City of Hamilton

PUBLIC WORKS COMMITTEE REVISED

Meeting #: 21-016
Date: November 1, 2021
Time: 1:30 p.m.
Location: Due to the COVID-19 and the Closure of City Hall (CC)

8.1.	Hamilton Water Leak Detection Program (PW21063) (City Wide)	82
8.2.	Update to Hamilton's Solid Waste Collection Design Guidelines for Developments (PW21061) (City Wide)	107

2
A0.04 92 JOHN STREET - PROPOSED HAMMERHEAD IMPACTS
1:200

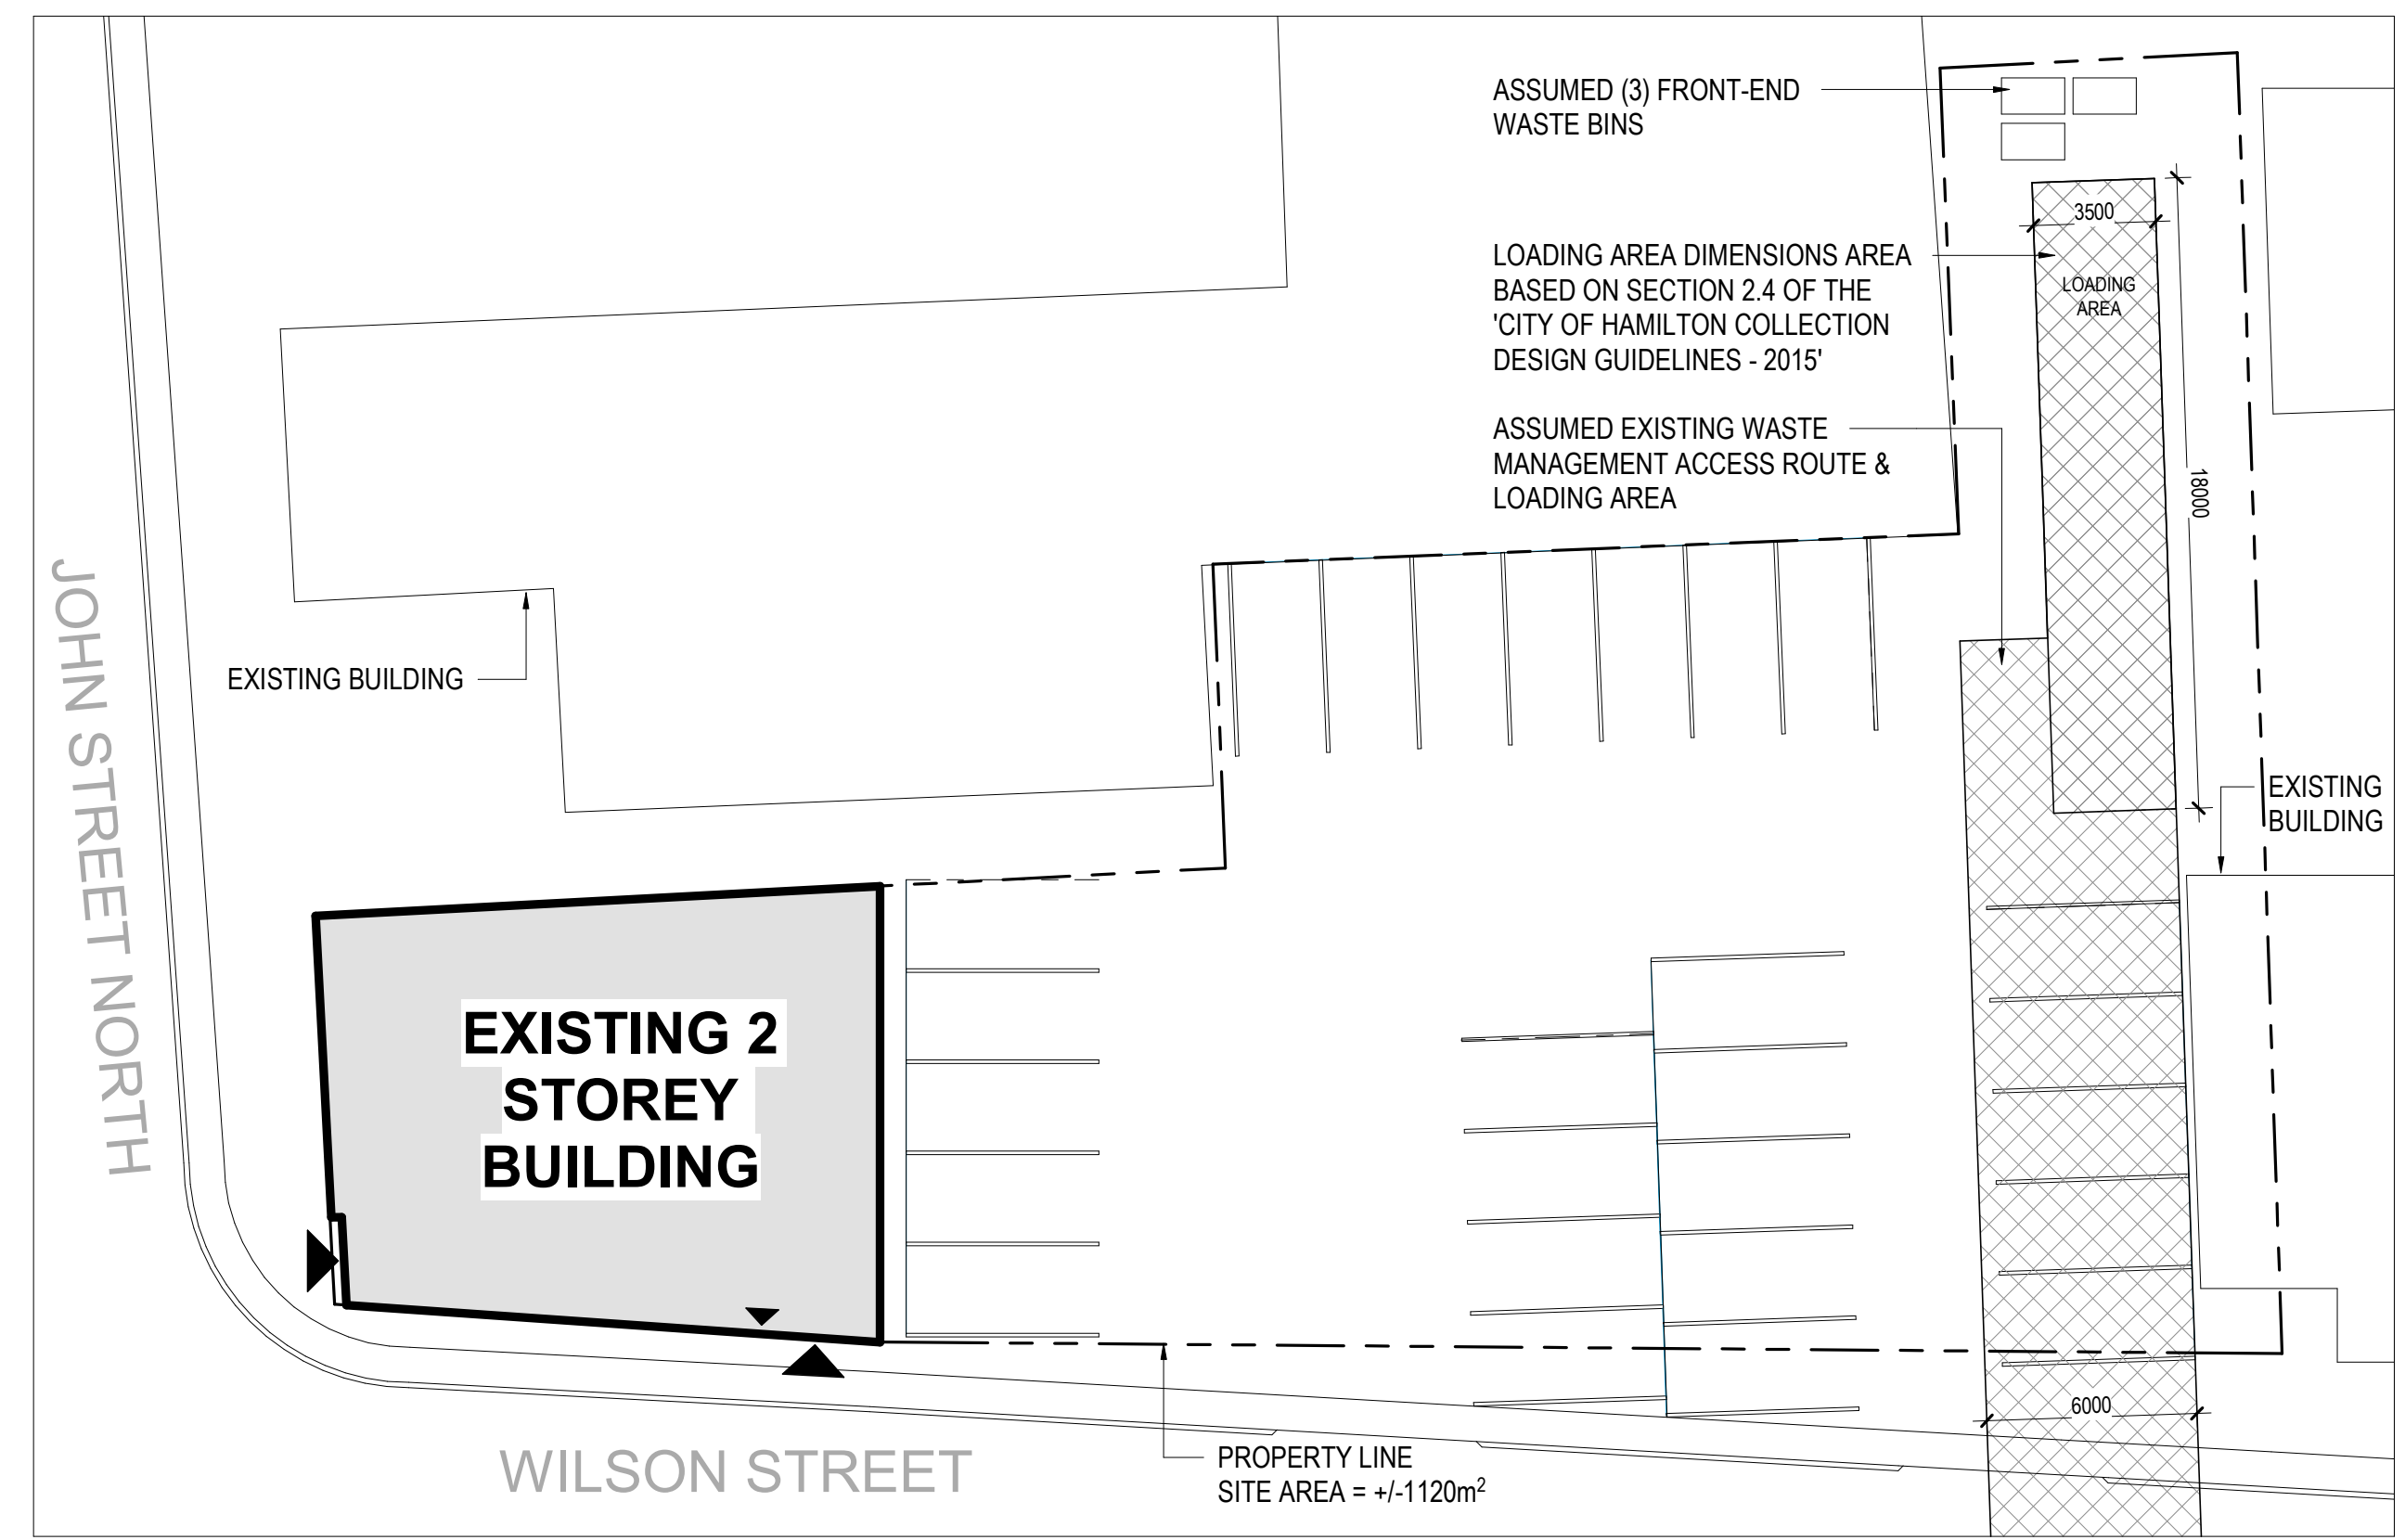
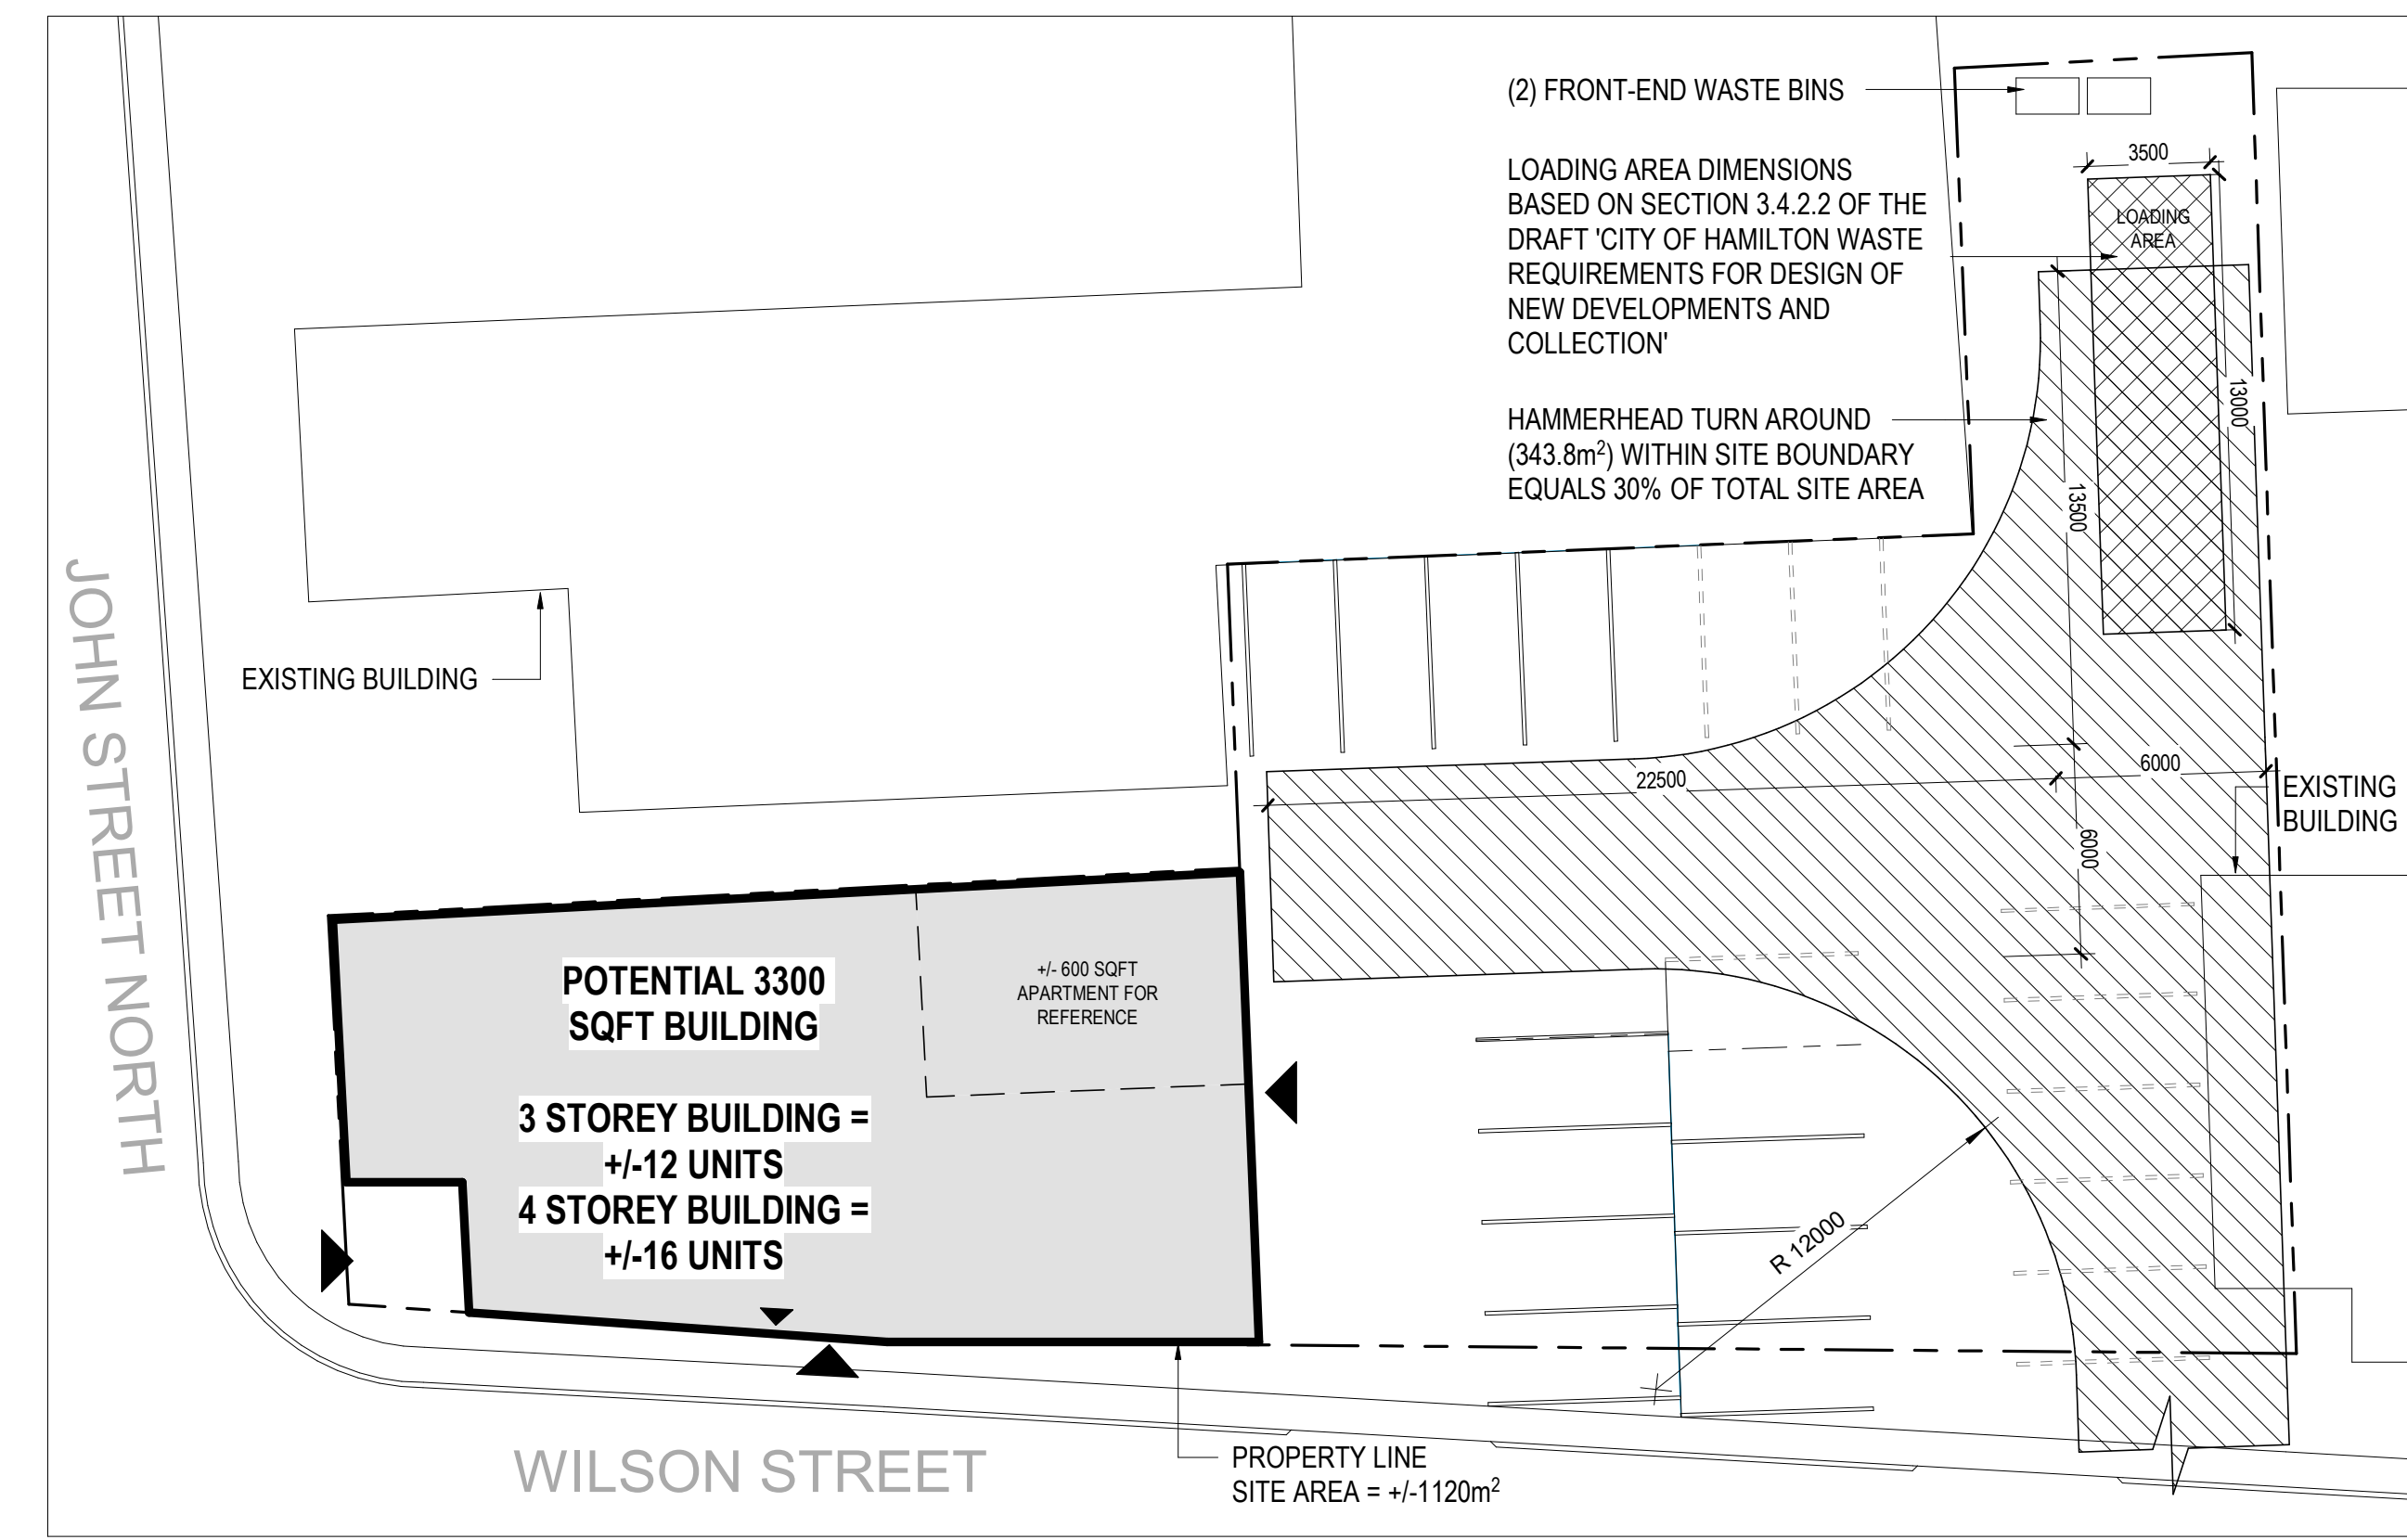
- SIGNIFICANT LOSS OF PARKING DUE TO HAMMERHEAD SPACE REQUIREMENTS AND INCREASED BUILDING FOOTPRINT TO ALIGN WITH GOALS OF INTENSIFICATION (13 SPACES LOST)
- REDUCTION OF BUILDABLE AREA AND RESIDENTIAL UNIT ALLOWANCE DUE TO LIMITED PARKING CAPACITY
- ADDITIONAL STOREYS BASED ON ZONING HEIGHT LIMITS WOULD MEAN THE BUILDING FALLS INTO 'LARGE MULTI-RESIDENTIAL' GARBAGE REQUIREMENTS AND WOULD REQUIRE MORE SPACE FOR GARBAGE
- EXISTING NEIGHBOURING BUILDING WOULD REQUIRE DEMOLITION
- GOALS FOR INTENSIFICATION WOULD BE REDUCED DUE TO PROPOSED HAMMERHEAD REQUIREMENTS

TOTAL LOSSES:

26 PARKING SPACES IS REDUCED TO 13

REDUCTION OF PARKING MEANS REDUCTION OF POTENTIAL UNITS

1 SITE PLAN - Isabella (Ottawa)
A0.07 1:150

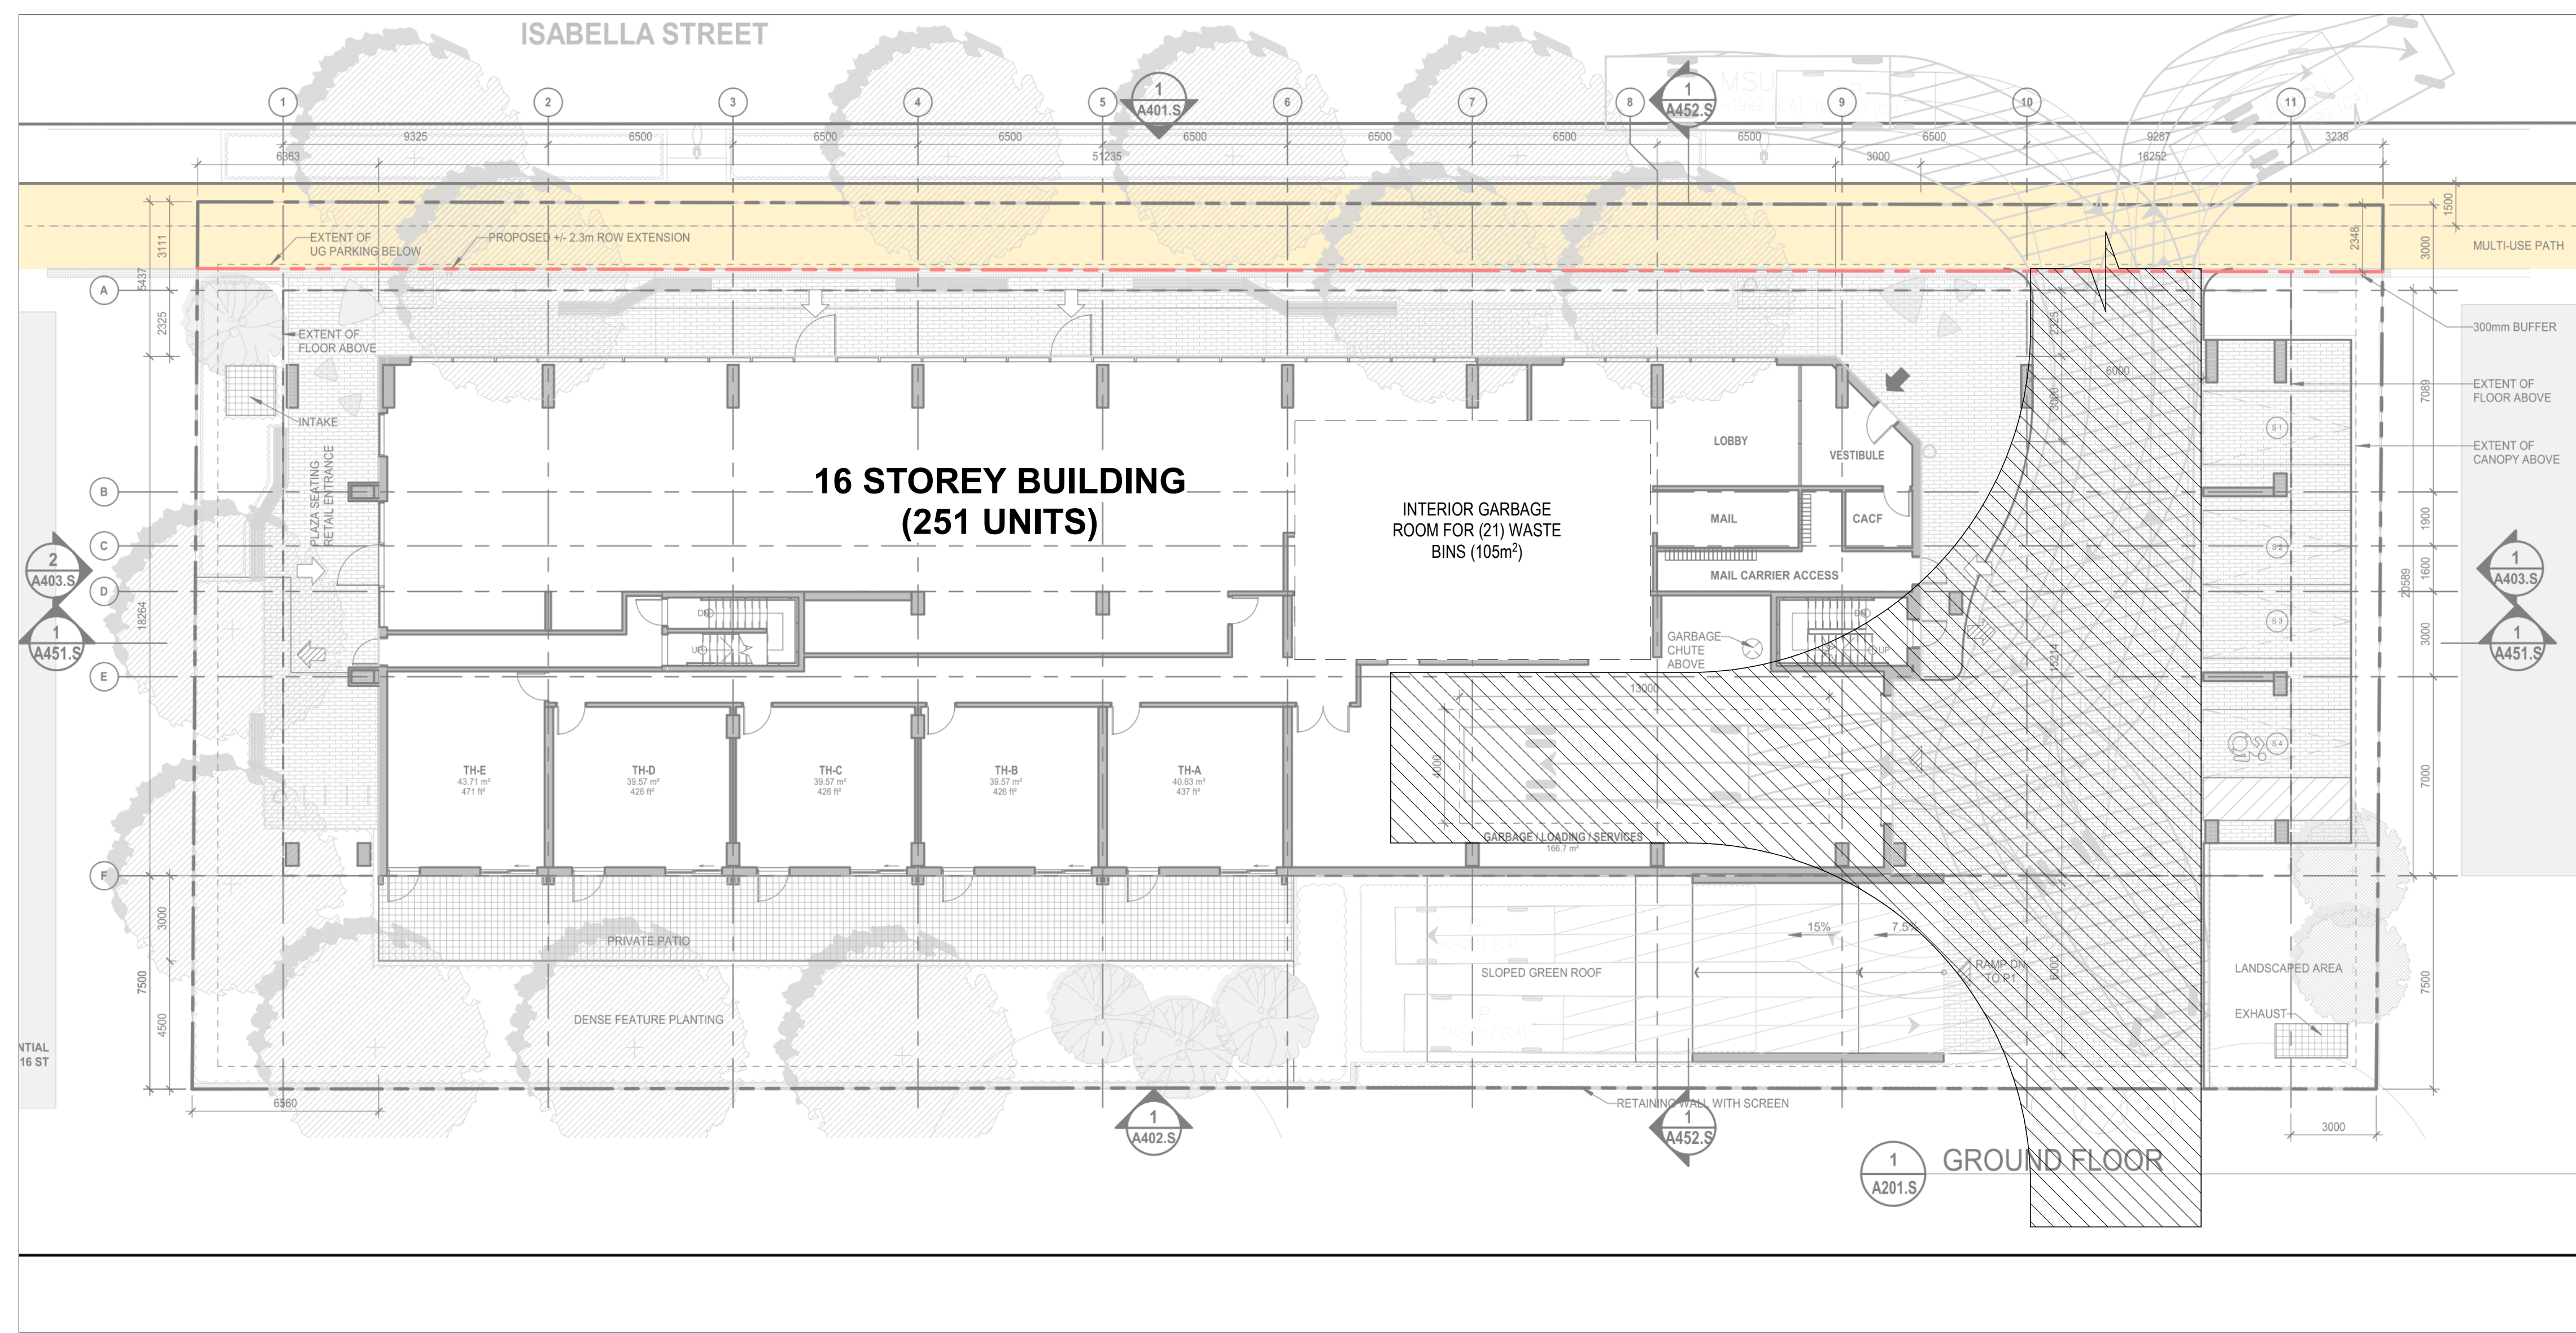
- 16 STOREYS = LARGE RESIDENTIAL
- GARBAGE, RECYCLING AND GREEN CARTS
- >12 GARBAGE CONTAINERS (UNCOMPACTED)
- 6 (+?) GARBAGE CONTAINERS (COMPACTED)
- 12 RECYCLING ORGANIC CONTAINERS
- 3 ORGANIC FRONT END CONTAINERS

= 21 CONTAINERS @ 5m2 EACH
= 105 m2 STORAGE

SITE RESULTS DUE TO PROPOSED DRAFT HAMMERHEAD IF THE PROJECT WERE IN HAMILTON:

- LOSS OF UNITS AND OVERALL BUILDABLE AREA DUE TO REQUIRED HAMMERHEAD
- LOSS OF UNITS DUE TO SPACE REQUIREMENTS FOR INTERIOR GARBAGE STORAGE
- PROJECT WOULD REQUIRE SIGNIFICANT REDESIGN IF PLANNED FOR THE CITY OF HAMILTON
